Re: Docket No. 40-8943
License No. SUA-1534
Response to Request for Additional Information

Response to Request for Additional Information

Groundwater Remediation for Casing Failure at Crow Butte In-Situ Leach Facility

Figure 1

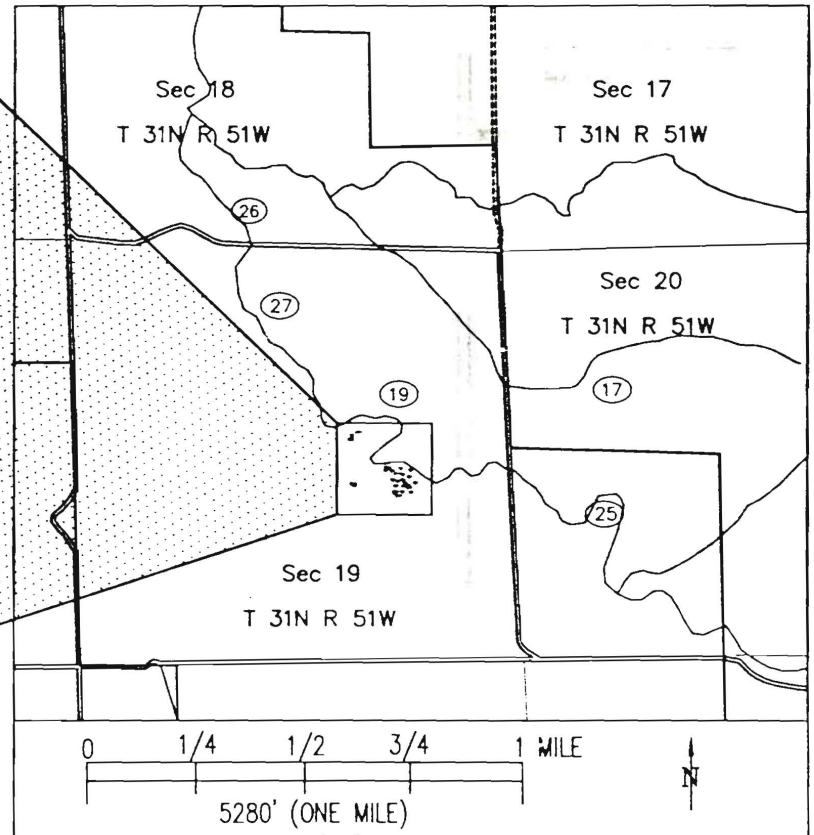
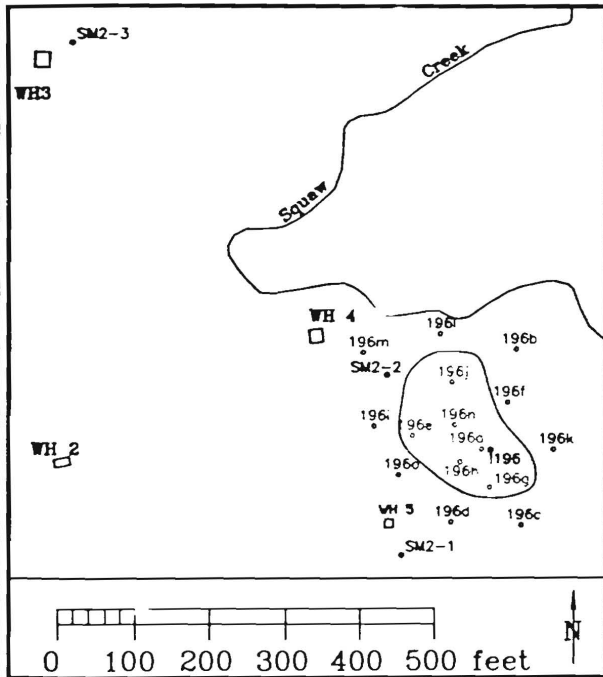
NRC Question Number 1) *CBR must demonstrate achievement of the primary restoration goal for the water quality parameters identified in License Condition 10.3.*

Data from the CBR environmental monitoring program may be used to determine whether the excursion remediation has been successful for all of the restoration constituents from License Condition 10.3(B). CBR has determined that five of the nearby 1-Km private wells closely approximate the groundwater quality in the vicinity of the excursion from I-196-5. These wells are in relatively close proximity to Well I-196-5, are completed in the upper Brule aquifer and have a similar average water depth of 35 to 40 feet. The five similar wells are identified as Wells Number 17, 19, 25, 26, and 27 in the commercial license application. Table 2 is a summary of the average preoperational baseline sampling results from these five 1-Km wells from 1982 through 1989. The preoperational monitoring for these wells was performed for all parameters required in License Condition 10.3(B).

Figure 1 shows the geographical location of these five 1-Km private wells in relation to the I-196-5 excursion area.

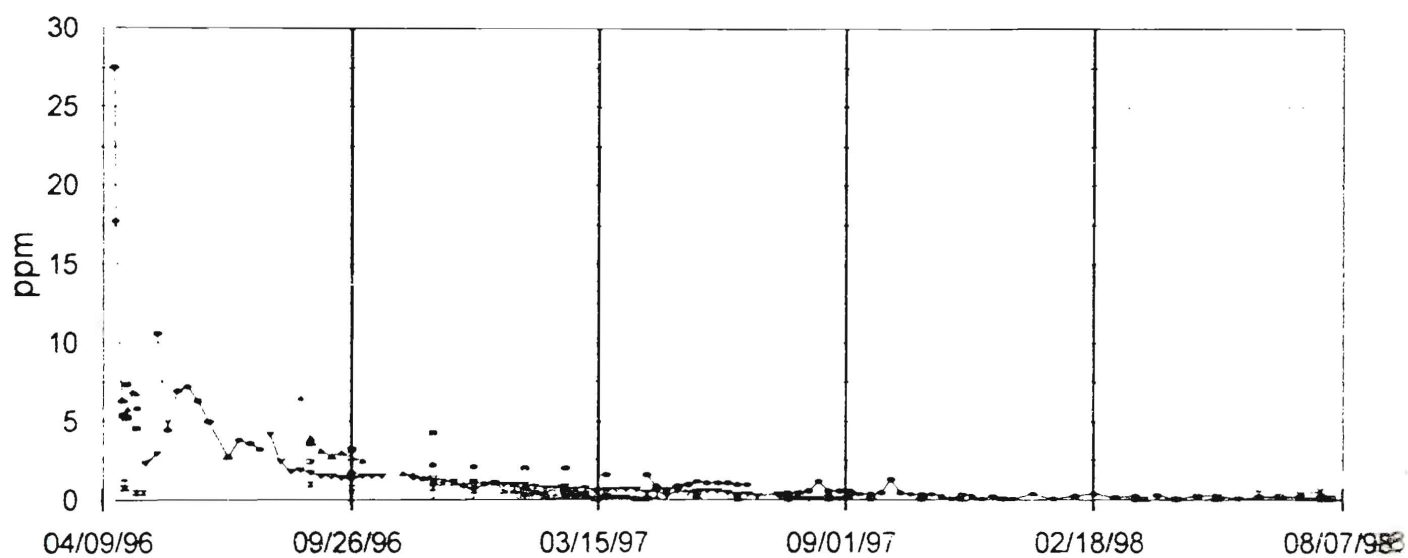
NRC Question Number 3) *CBR should provide a description of the shallow aquifer in the excursion area and its relation (thickness, separating aquitards, etc.) to the mine zone and any overlying aquifers.*

The excursion aquifer is located in the upper portion of the Brule Formation within a silty sandstone lens. The upper portion of the Brule Formation is primarily light brown to medium brown siltstones with occasional discontinuous sandstone and silty sandstone lenses. The upper portion of the Brule ranges in thickness from 180 feet to 265 feet in the excursion area. Underlying the upper portion of the Brule is a 300-foot thick sequence of siltstone, mudstone, and claystone of the lower portion of the Brule and the upper portion of the Chadron Formations. The sequence represents the upper confinement to the mining zone located within the basal Chadron Formation sandstone. Based on the original geophysical log for well I-196-5 the excursion aquifer is approximately 560 feet above the mining zone.

The excursion has not been detected in the shallow monitor wells for Mine Unit 2, indicating that the excursion was confined to the shallow water-bearing silty sandstone 40 feet below the surface. The excursion delineation wells installed in 1996 have effectively defined the areal extent of contamination within this silty sandstone.
